Comments on DCM for 2025 Comment Period

Submitted by The Friends of Fourmile volunteer chapter of the Greater Arkansas River Nature Association, June 17, 2025

Prepared by Alan Robinson, Friends of Fourmile (FoF) Agency Contact, with input from chapter members.

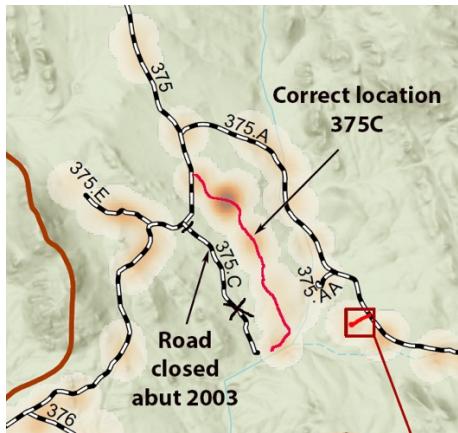
On Map 8 proposed road additions N of 24. The actual on-the-ground location of 375C is not correct. It should be located as in the screenshot below.

We assume this inaccuracy is because you used the current NMVUM to delineate system routes in preparing this map, and in this instance, the NMVUM itself is inaccurate. To confirm that our suggested relocation is correct, note the heat map of use is along the relocated 375C where indeed there are a dozen or more GPSd dispersed campsites. The accurate 375C dead ends as indicated, at a location known as the historic Homestead. *We recommend you use this opportunity to correct the NMVUM, just as you will be recommending certain long spurs be granted system route status after designated site layout.*

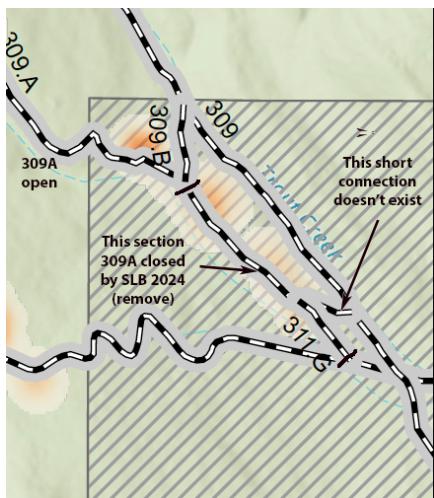
On Map 8 proposed road additions N of 24. There has been a 2024 permanent closure of a portion of 309A on lands owned by the State Land Board, as seen in the following clip.

We recommend you take this opportunity to correct the NMVUM, just as you will be recommending certain long spurs may be granted system route status.
